ESTANCIA PHASE 11 CONDOS

**830 ESTANCIA PARKWAY
SP-2023-0032C**

VARIANCE REQUEST

EXISTING CONDITIONS

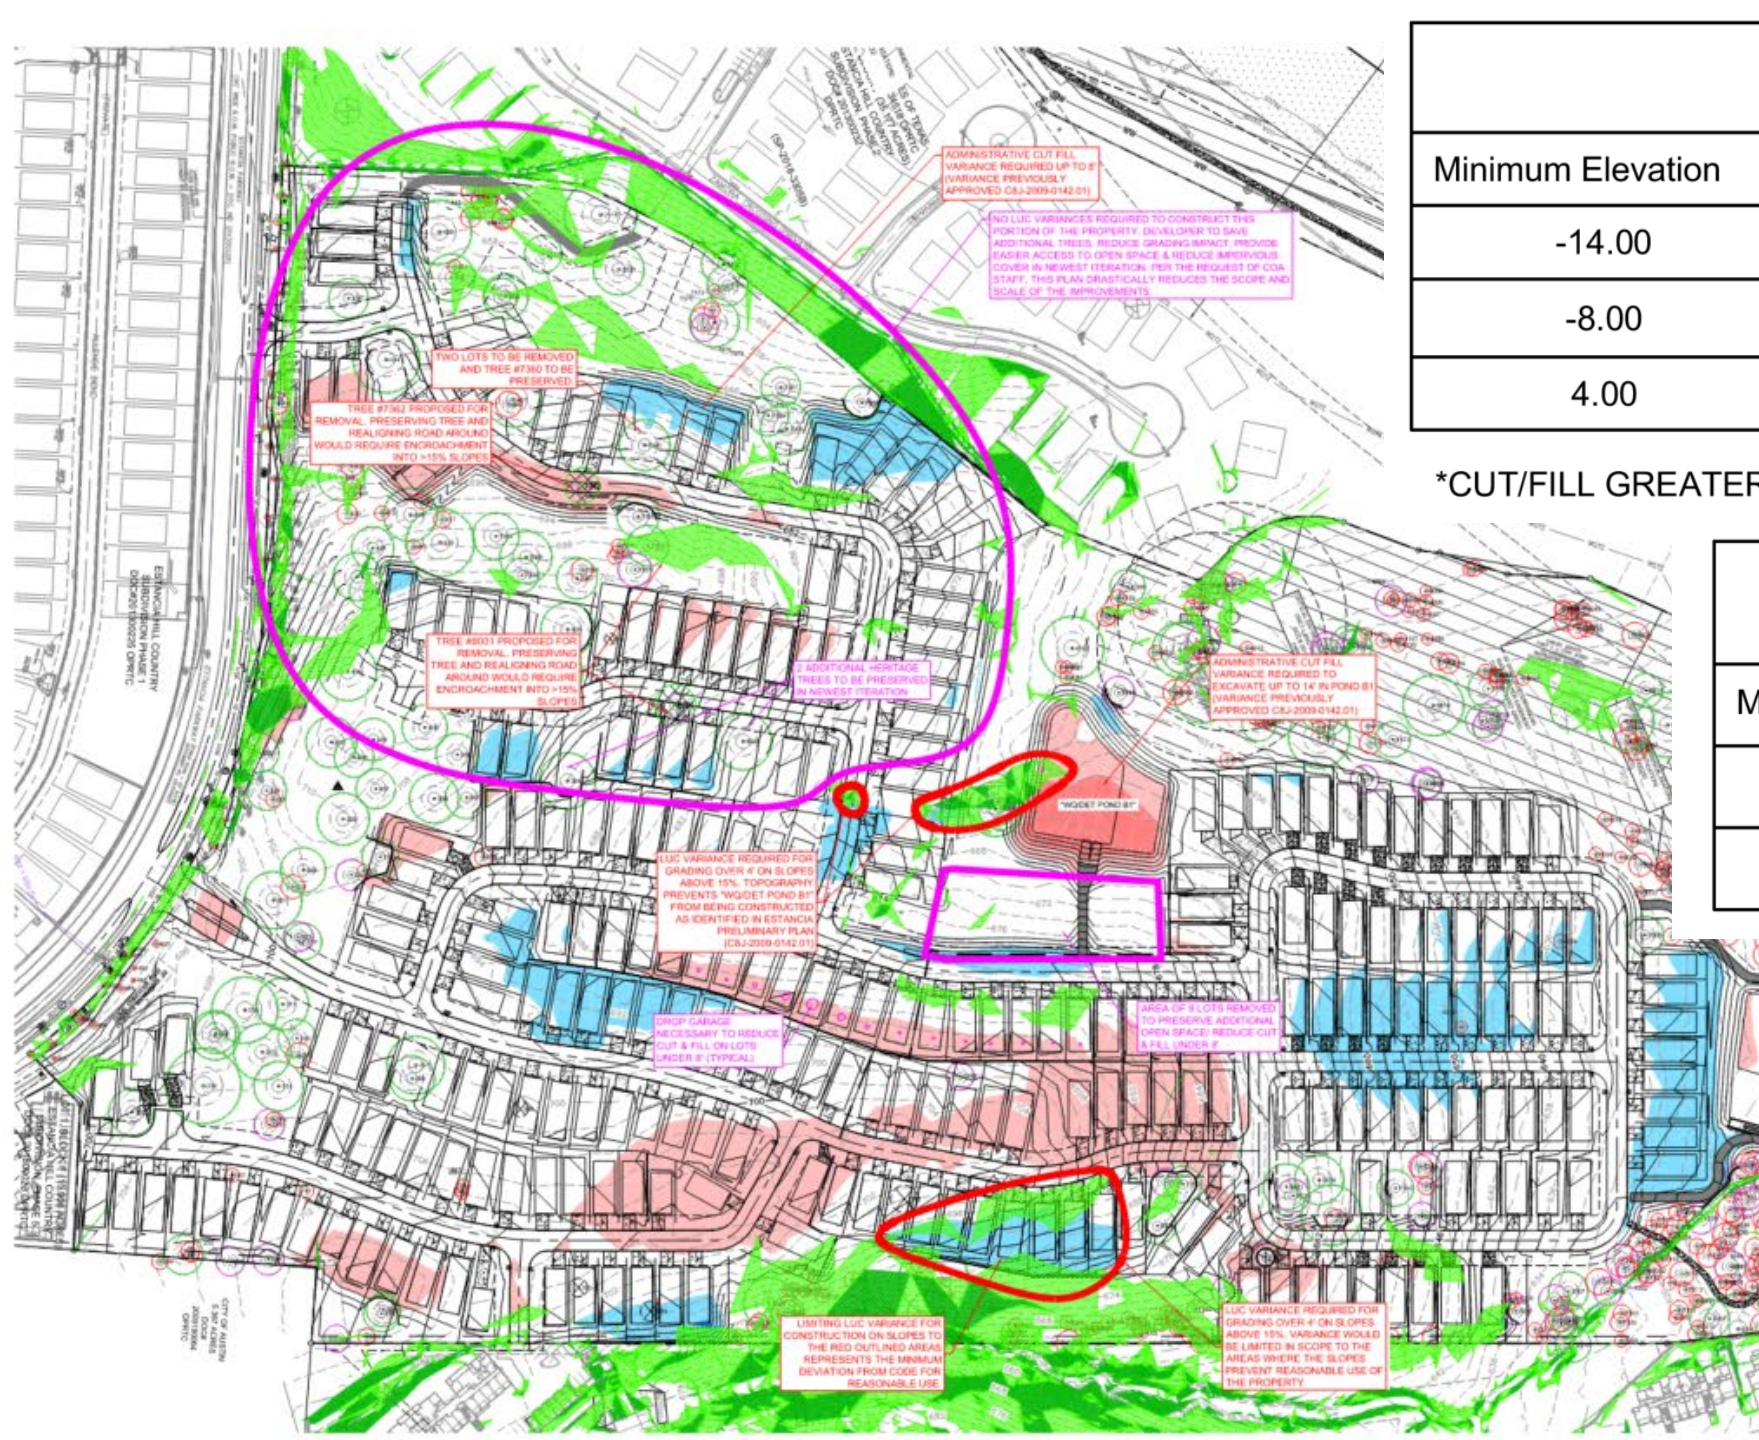
Administrative variances were granted with the Preliminary Plan C8J-2009-0142.01 for grading up to 14 feet for water quality/drainage facilities and for grading up to 8 feet throughout.

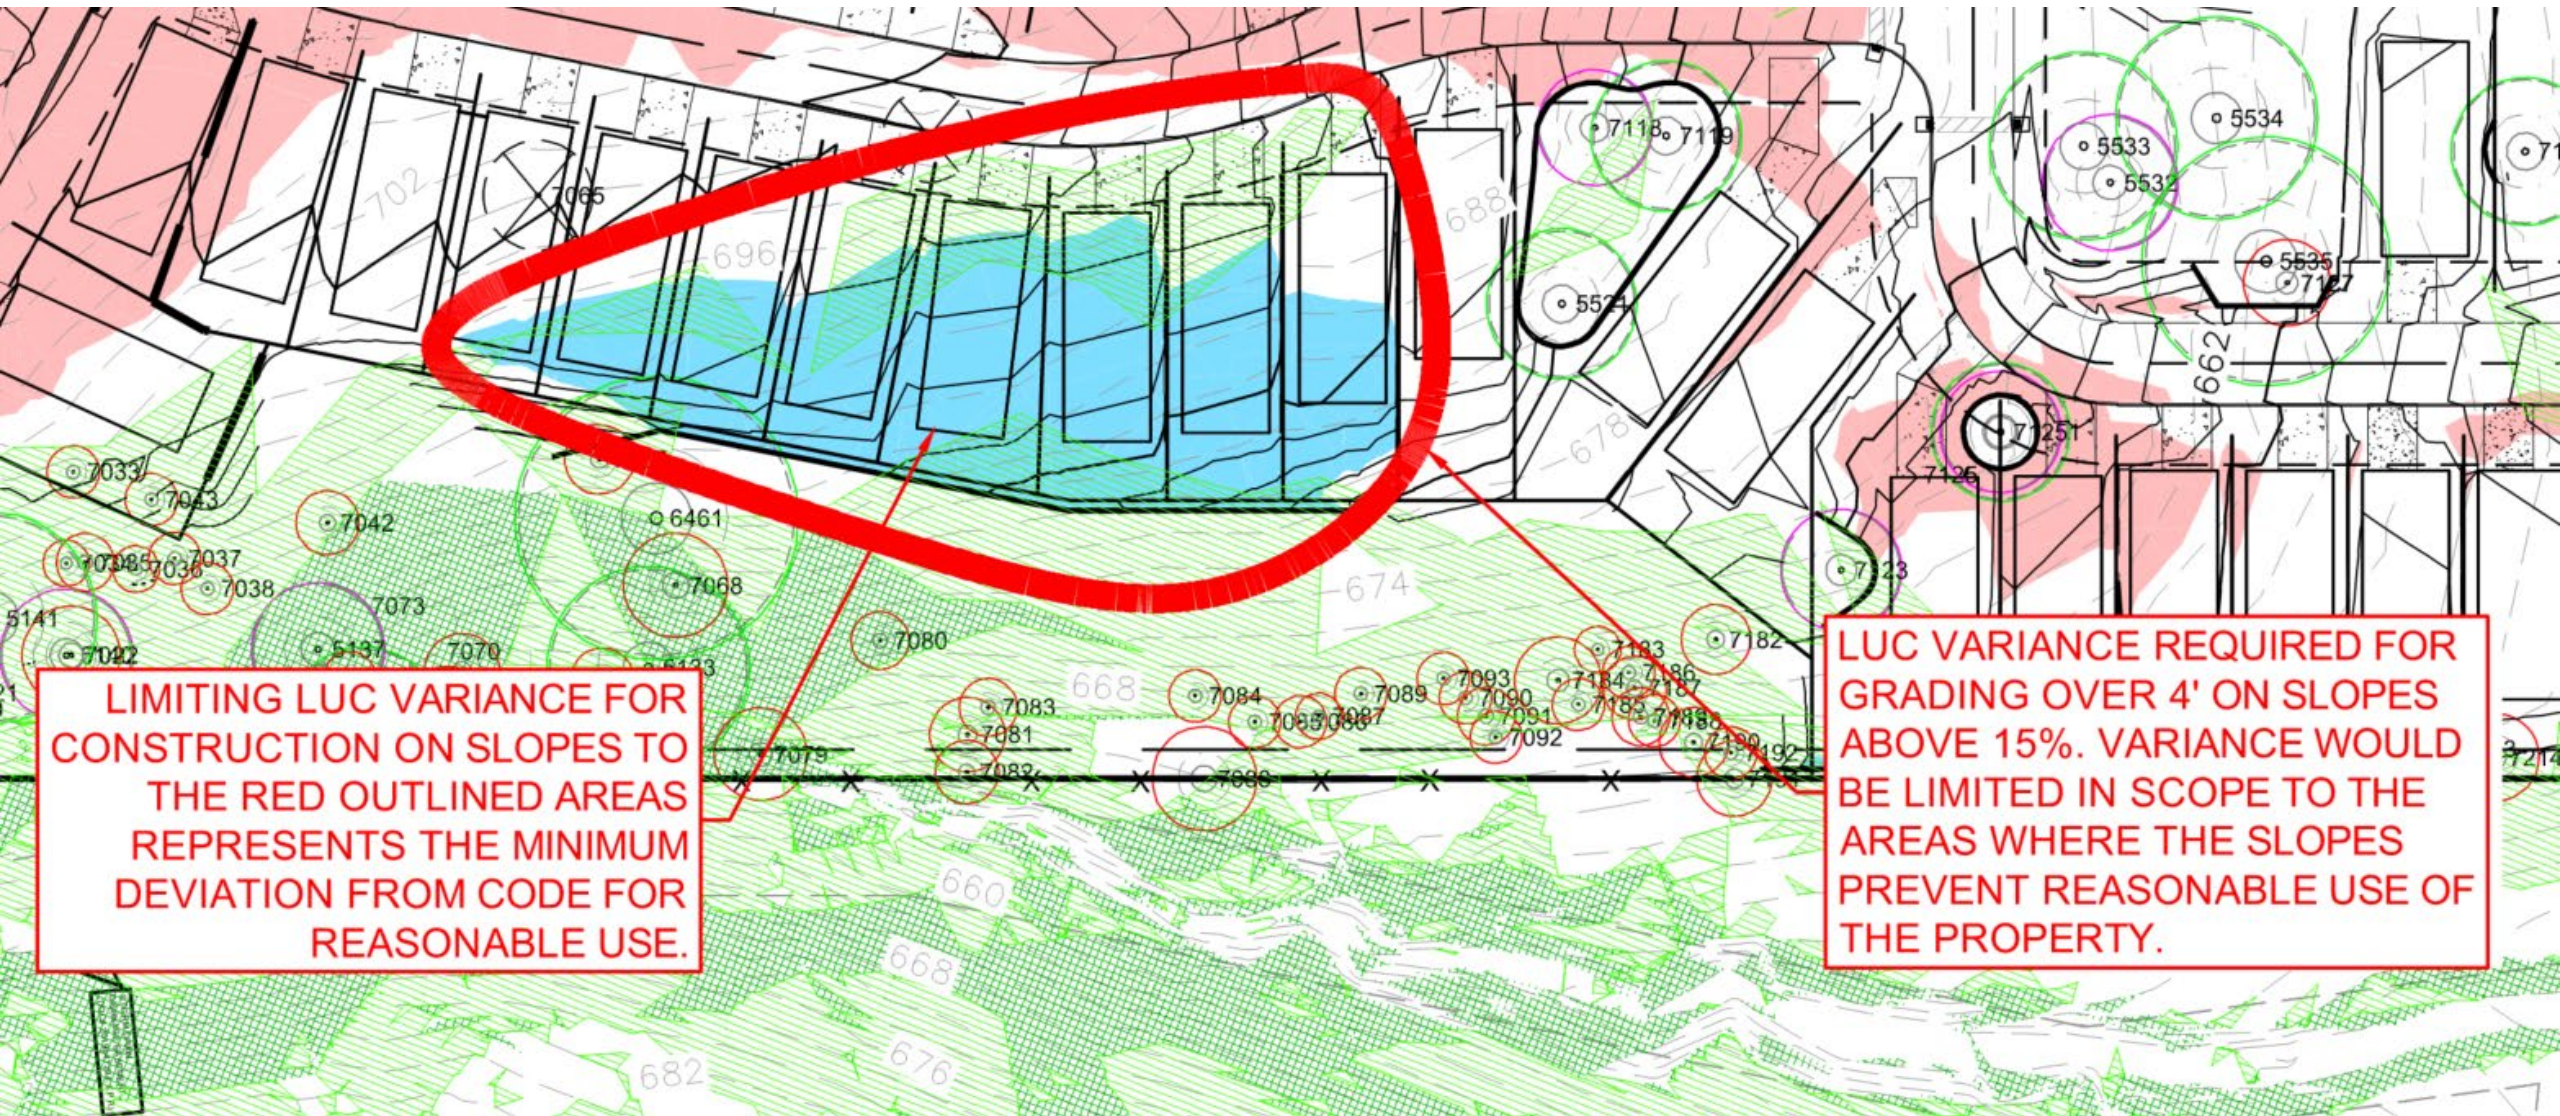
LIMITING LUC VARIANCE FOR CONSTRUCTION ON SLOPES TO THE RED OUTLINED AREAS REPRESENTS THE MINIMUM DEVIATION FROM CODE FOR REASONABLE USE.

LUC VARIANCE REQUIRED FOR GRADING OVER 4' ON SLOPES ABOVE 15%. VARIANCE WOULD BE LIMITED IN SCOPE TO THE AREAS WHERE THE SLOPES PREVENT REASONABLE USE OF THE PROPERTY.
